JERSEY CENTRAL POWER & LIGHT COMPANY

OYSTER CREEK NUCLEAR GENERATING STATION

ECCS MODIFICATION

CORE SPRAY ELECTRICAL CROSSCONNECT

FIGURE 2-3

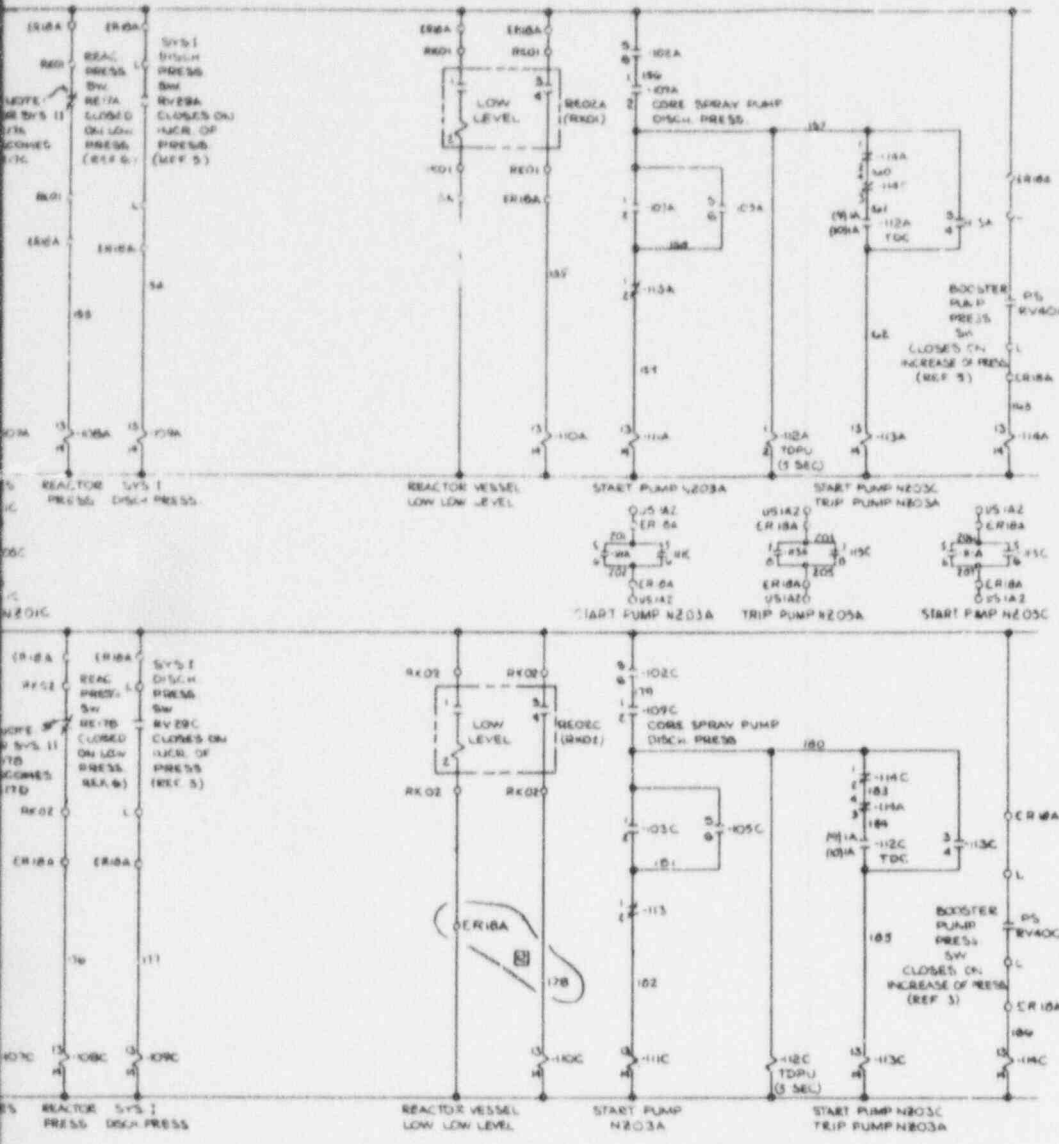
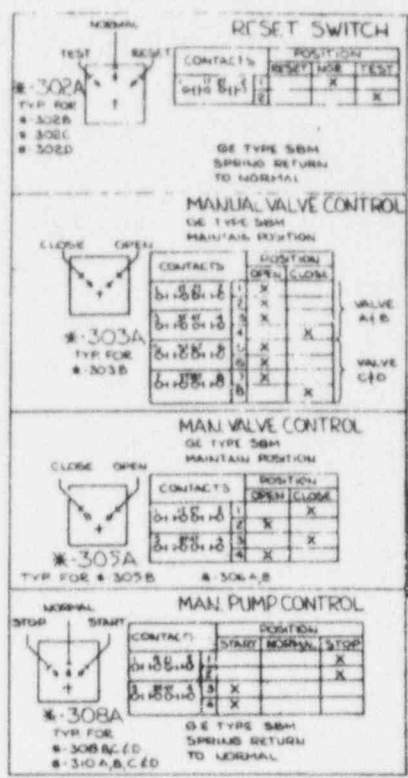
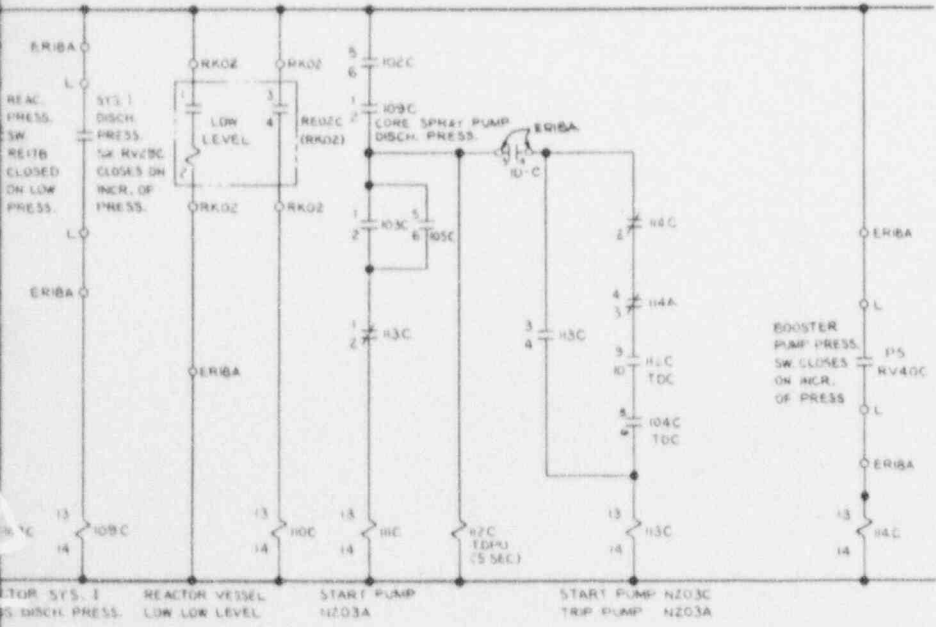
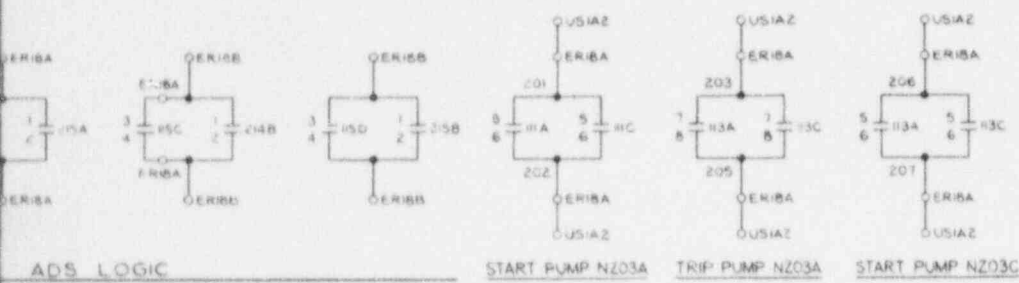
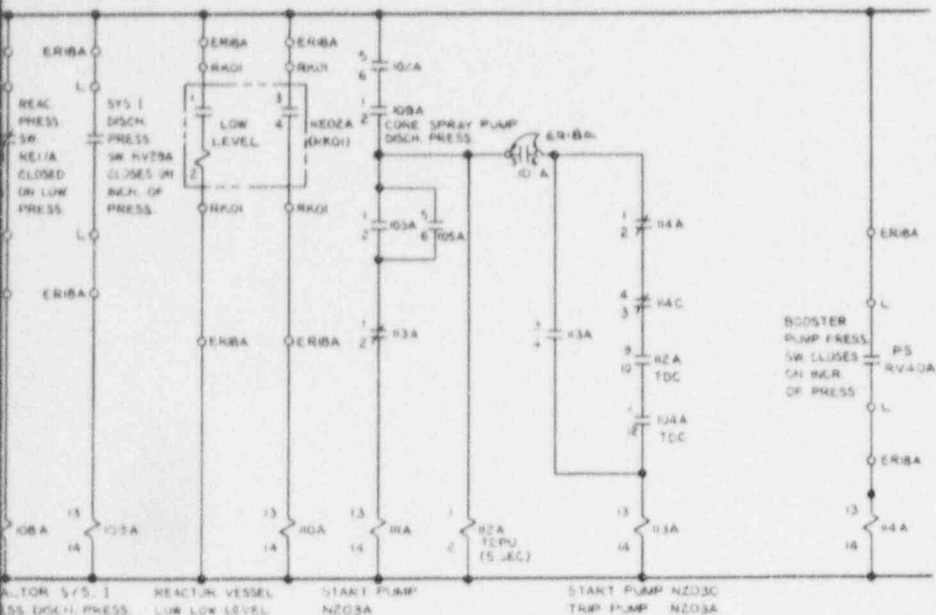
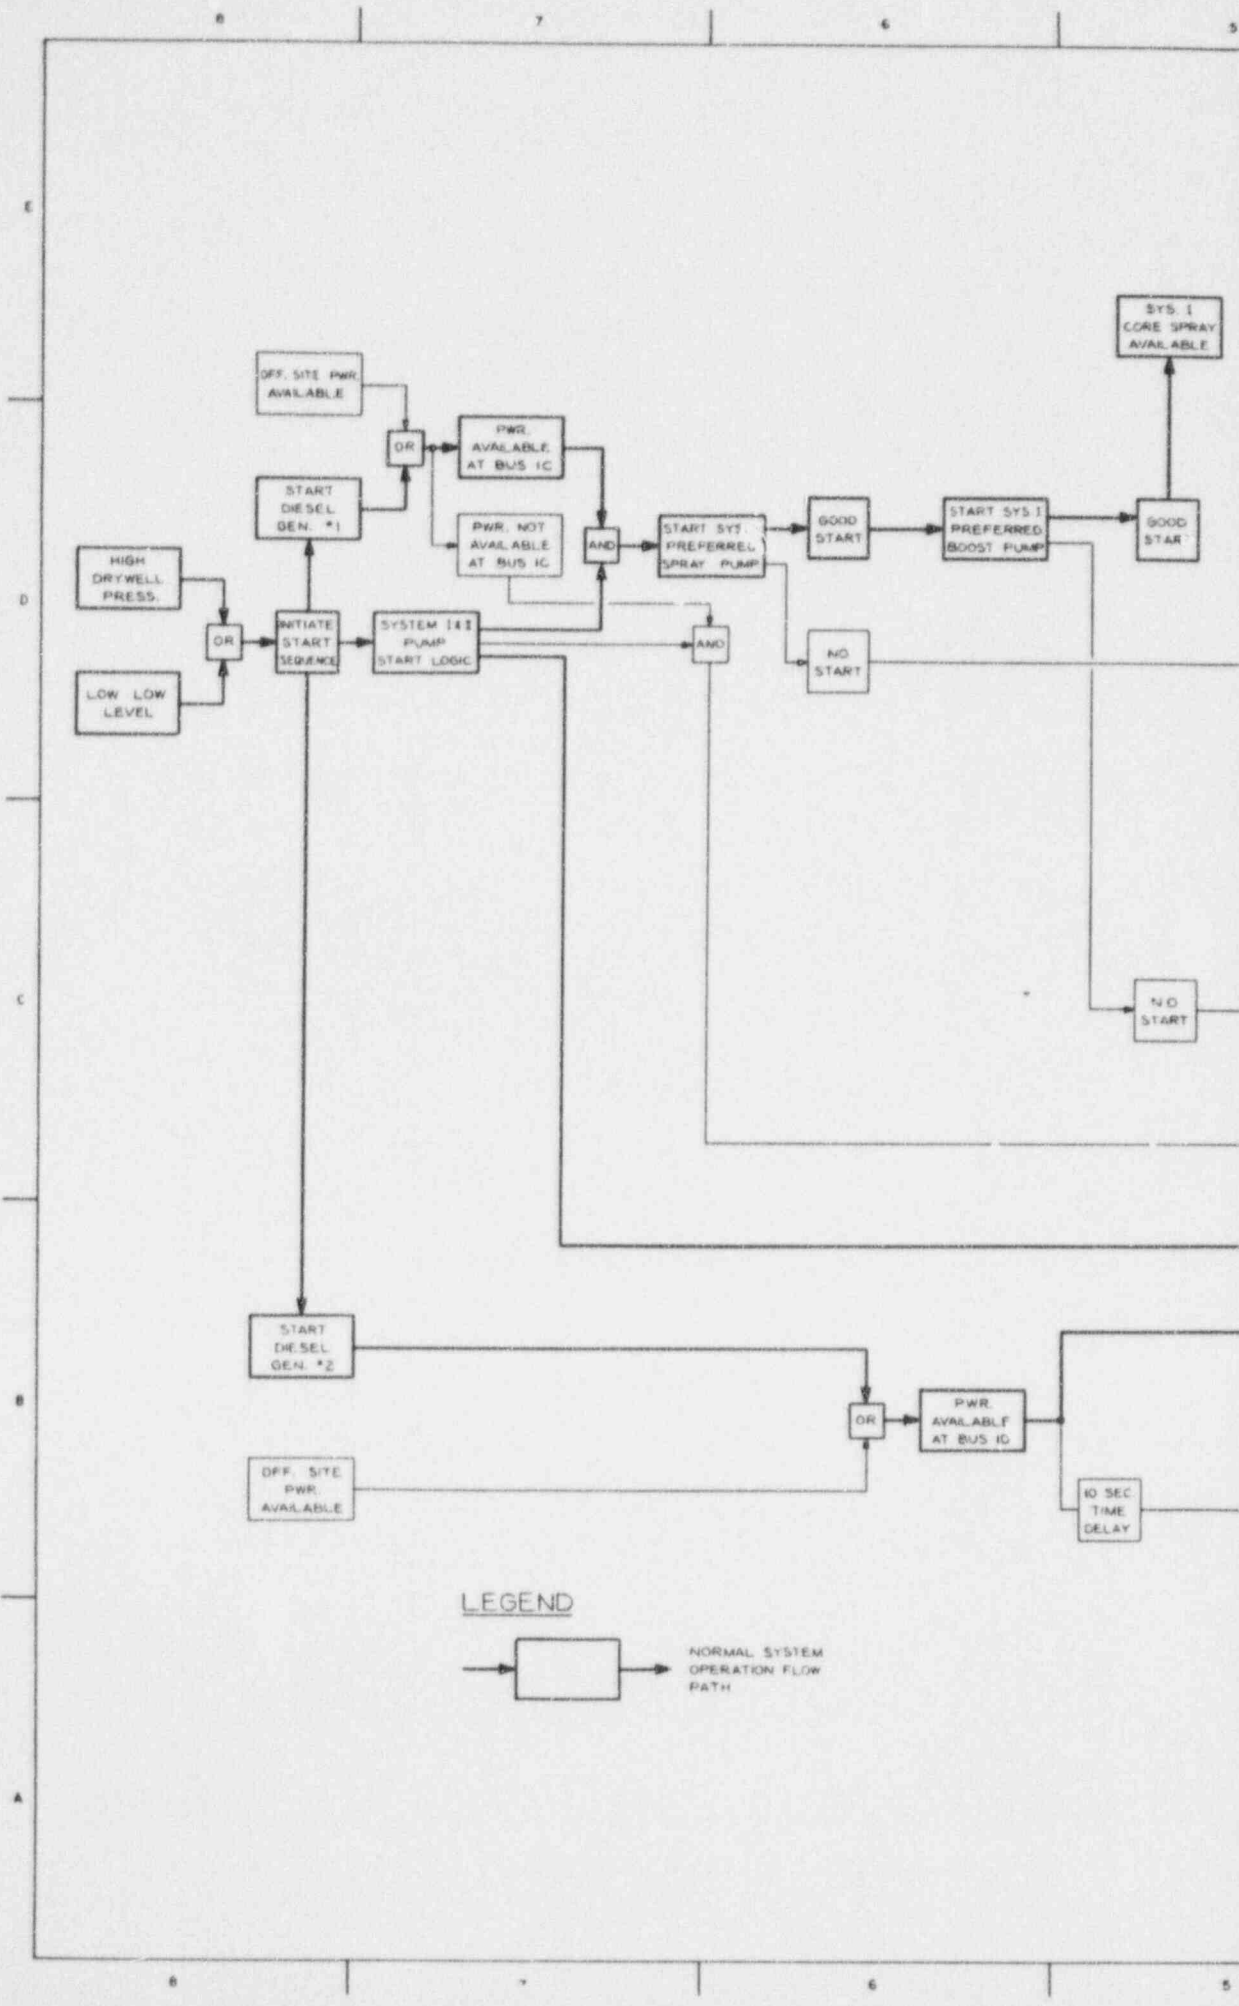
The existing core spray system actuation logic is presented in Figure 2-3. Modification of the existing logic is presented in Figure 2-4. The modification does not alter the normal core spray system start sequence. Additional constraints or conditions have been added to the start sequence logic so that one of the two existing diesel generators will not be required to support the load transient associated with the simultaneous starting of any two core spray system pumps. To assure that the control logic cannot command the simultaneous starting of two pumps on the same diesel generator bus, interlocks have been added to provide concurrent start sequences for both core spray fluid systems. The start sequence interlocks increase the start sequence reliability. The modification to the control system logic will automatically start both diesel generators and initiate the core spray system pump sequence in both fluid systems if either a low-low reactor level or a high drywell pressure signal is present in any one of the four core spray system logic channels.

With the modification, the start sequence interlock must be inhibited when a logic channel is in test to prevent test signal starting of the pumps in the loop not being tested. Four keylock switches will be used for this purpose (one for each logic channel). Only a single key will be available to assure that

only one start sequence interlock circuit can be disabled. An alarm in the control room will indicate when any start sequence interlock circuit is inhibited. After logic channel test, the control room has a positive indication when the interlock circuit is restored.

- o The modified CSS actuation logic initiates total system response (diesels 1 and 2 start and systems I and II pressurization) upon the receipt of a high drywell pressure signal or a low-low reactor water level signal to a single actuation channel. (See Attachment II, Items 509A, 514A and Figure 2-4.)

- o The drywell pressure switches RV46B and RV46C shall be reassigned to CSS actuation channels C and B, respectively. (See Attachment II, Item 576A and Figure 2-4.)

FIGURE 2-5

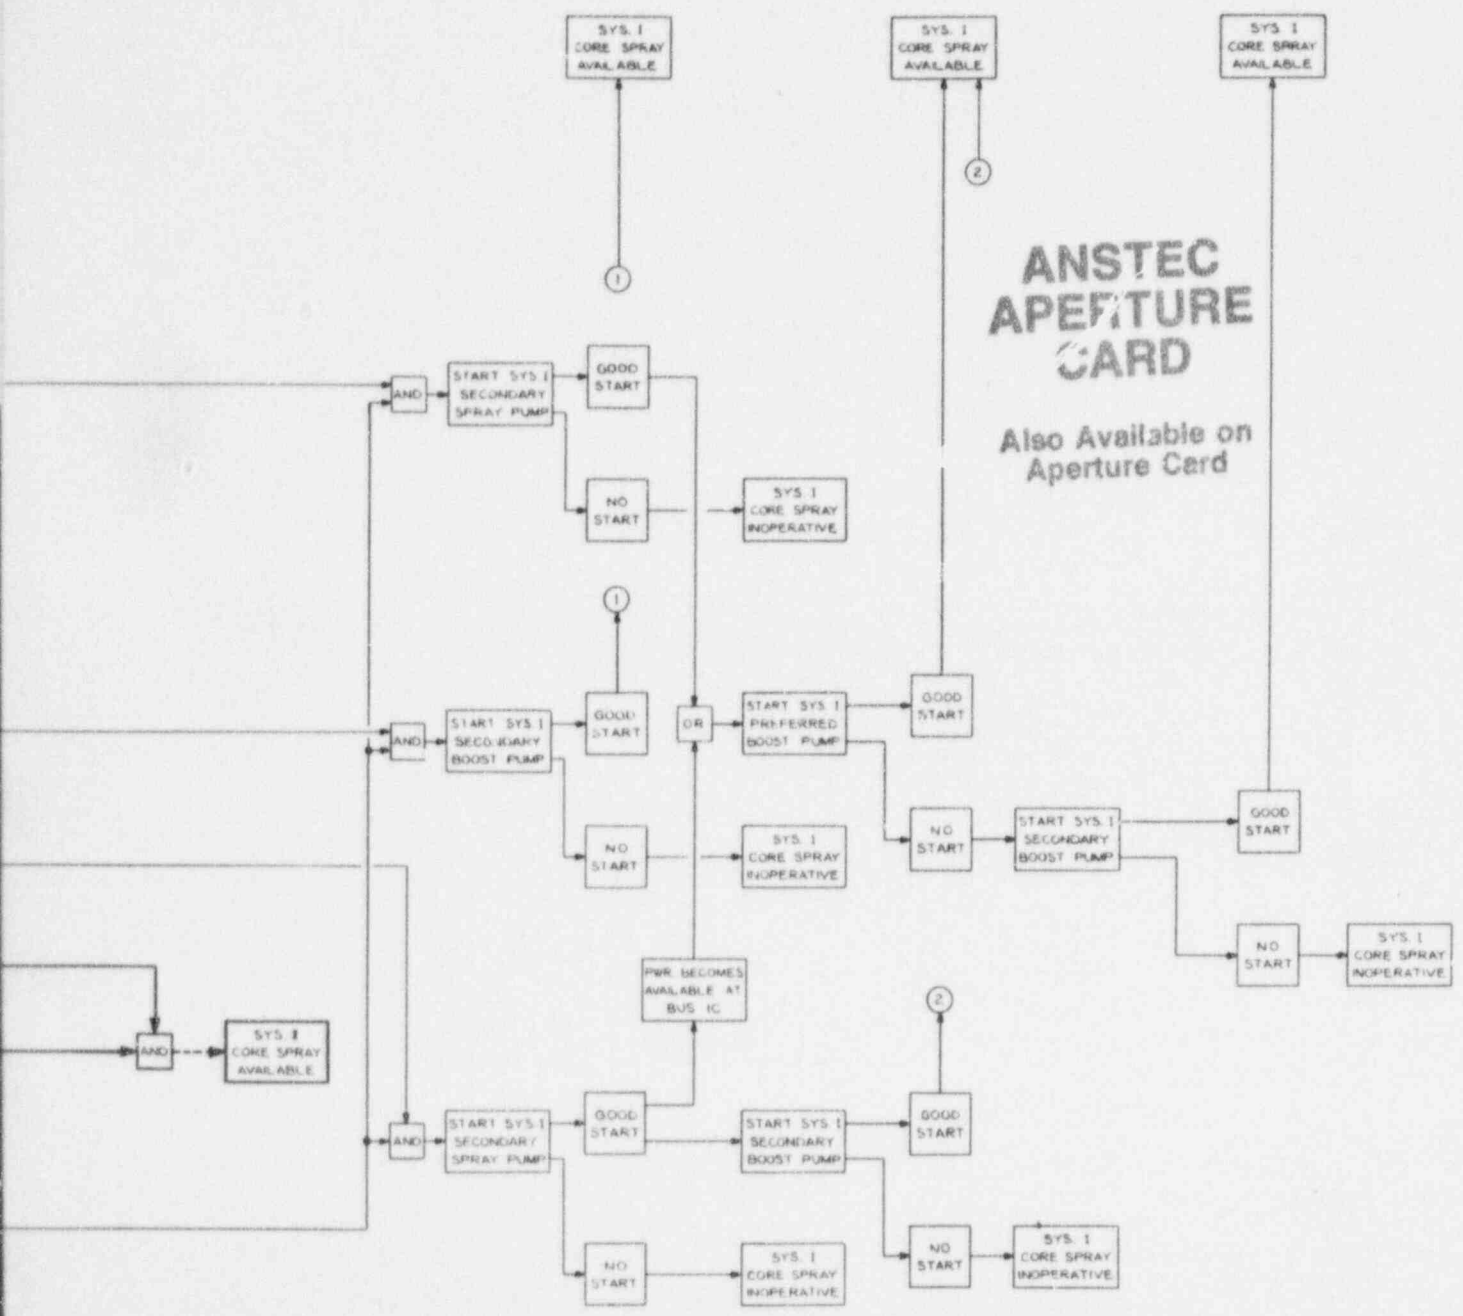
Figure 2-5 presents the core spray control system pump start sequence block diagram for the modification. The diagram depicts the starting sequence associated with fluid system I. All interfaces with fluid system II have been identified. The starting sequence associated with system II may be directly translated from Figure 2-5 by substituting system II for system I and bus 1D for bus 1C. The nominal starting sequence is highlighted by the bold block outline. Figures 2-4 and 2-5 disclose that with the nominal starting sequence, each core spray fluid system is available ten seconds after the start signal sequence and power is available at the associated bus. If no power is available at one bus, both fluid systems will automatically start. The fluid system with the preferred pumps operating is available ten seconds after the start sequence signal. The other fluid system is available fifteen seconds later.
